# NATIONAL COMPACT STELLARATOR PROJECT

## Engineering Change Proposal (ECP)

**ECP No:** ECP-04-001

**ECP Title:** Revision 1 to the General Requirements Document

Figure 3-2 NCSX Coordinate System

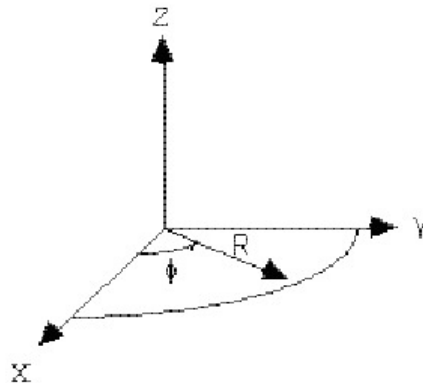
Updated Figure 3-2 per Nelson comment (cosmetic change only).
